Cockenzie and Longannet power stations: novel features in the design and construction

L. H. BAKER & D. H. McPHERSON

DISCUSSION

Fig. 22. Mines in Longannet area

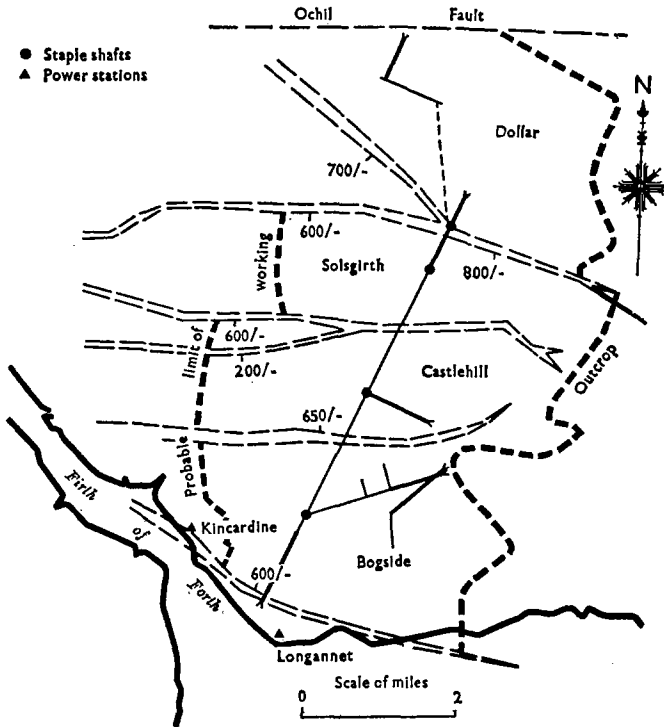
132. Figure 22 shows the Longannet mine complex which serves the station. It is not designed to produce the peak requirement, about 12 000 tons every 24 hours, but the great bulk of the coal requirements of the station. It consists of four mines: Bogside, Castle Hill, Solsgirth and Dollar, all designed to be connected together to a main conveyor road so that the coal produced in all four mines reaches the station bunkers without ever seeing the light of day until it comes out of the ground at Longannet.

133. The four points in the figure marked with large black circles are those at which the coal from various mines reaches the main conveyor belt. Only three of

them are in commission. The Solsgirth mine has rather unkindly pirated some of the Dollar coal and the Solsgirth bunker has not been constructed, and may not be constructed.

Fig. 23. Cofferdam bracing

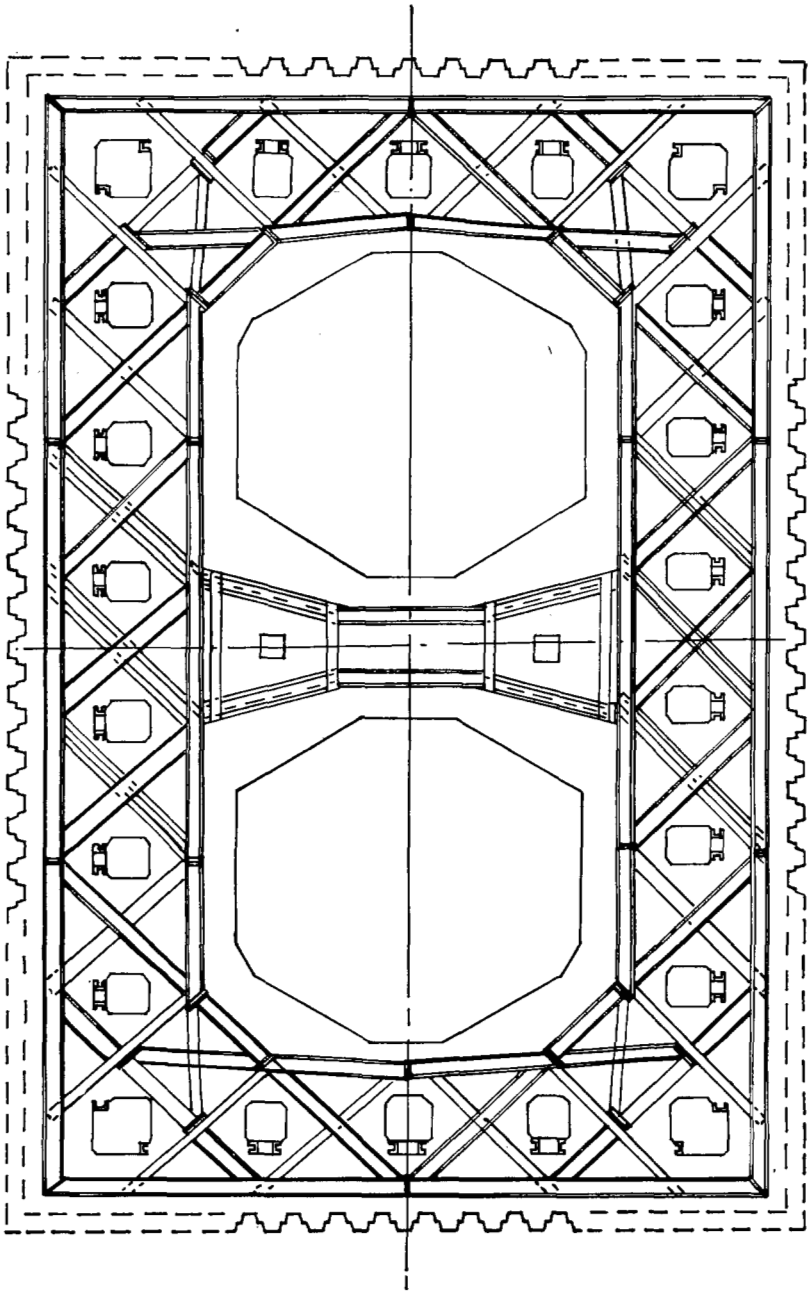
152. The parameters that I was given were broadly three: (a) Larsen 4B piles in high yield steel would be used, fitted with rock driving tips; (b) frames 1 and 2 would be erected first on false-work and the piling pitched around them; (c) most important, the weight of the cofferdam bracing should not exceed the allowance made at the time of tender. The arrangement for bracing shown in the half plan in Fig. 7 was that designed at tender stage but not the configuration ultimately adopted, which is shown in Fig. 23.

153. The tender design calculations were taken from the triangular water pressure diagram, allowing for wave action, and dividing it up between the frames on the basis of all the frames being fixed, when the loads were shown to be 3.7 ton/ft for frame 1 and the remaining five frames varied from 5.7 to 6.1 ton/ft. On the particular calculation sheet was written the statement 'Design all walings for the maximum load of 6 ton/ft run.'

154. The truss illustrated in Fig. 7 was 'just stiff' and was analysed by resolution and the triangular forces, and, taking account of the axle load effects, the size of members determined in accordance with the requirements of BS 449 and the tonnage of steel were evaluated. What the designer failed to recognize, however, in the short time available at the time of tender was that frame loads during the transient conditions when the water inside the cofferdam was pumped out for the fixing of the lower frames were considerably at variance with the final condition. The actual loads were:

Frame 1	2.9 ton/ft
Frame 2	6 ton/ft
Frame 3	14.9 ton/ft
Frame 4	11.6 ton/ft
Frame 5	8.5 ton/ft
Frame 6	5.7 ton/ft

These figures were a long way from the 6 ton/ft which had been allowed. Indeed, it was found during the construction phase that the load in frame 2 rose to 9.9 ton/ft. It was, therefore, decided to design the frames for loads as follows: 6 tons, 10 tons, 15 tons, 12 tons, 10 tons and 6 tons.

155. In the detailing of the frames, the configuration shown in Fig. 23 was adopted to make construction of the peripheral columns simpler, the columns fitting neatly inside the spaces. This arrangement was not capable of analysis by conventional Bow's notation and graphical solution because it was statically indeterminate. Therefore, the framing was considered as a double portal on the centre line of the framing, and the bending moment and shear force diagrams were drawn using moment distribution.

199. **Mr Gayner's** comments are of considerable interest on the intake cofferdam, which was successfully used with less than desirable cut-off in an area subject to heavy seas but which enabled the structure to be solidly founded on good rock all over its base area.
